# **Proposal for ESF (c) – Emergency Assistance**

Working document ECE-TRANS-WP29-GRVA-2020-16e.docx

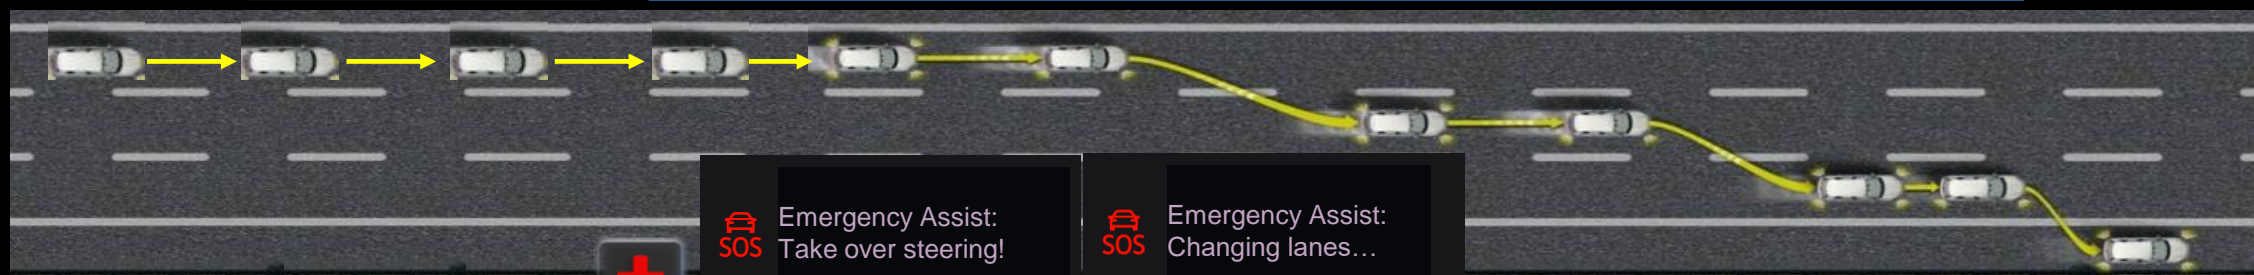
Annex 8, insert a new paragraph 3.3.6., to read: “3.3.6. Tests for ESF of type (c)

ESF of type (c) shall be tested under the nominal functional conditions according to the system information data. The vehicle with an ESF of type (c) shall be driven on a test track with multiple lanes per direction on the fastest lane. ESF (c) function shall be activated as described in the documentation.

The test requirements are deemed to be met, if both following test cases are fulfilled:

- 3.3.6.1. No critical situation as described in paragraph 5.1.6.2.3.2.2. is detected:
  - (a) The hazard warning lights / direction indicator are activated and
  - (b) The warnings specified in paragraph 5.1.6.2.6. of this Regulation. are provided no later than the ESF intervention starts and
  - (c) The lane changes into the direction of the target stop area are performed and the vehicle is brought to a standstill within the described target stop area.
- 3.3.6.2. A critical situation as described in paragraph 5.1.6.2.3.2.2. is detected:
  - (a) The hazard warning lights are activated and
  - (b) The warnings specified in paragraph 5.1.6.2.6. of this Regulation are provided no later than the ESF intervention starts, and
  - (c) The vehicle is brought to a standstill within its lane of travel.”
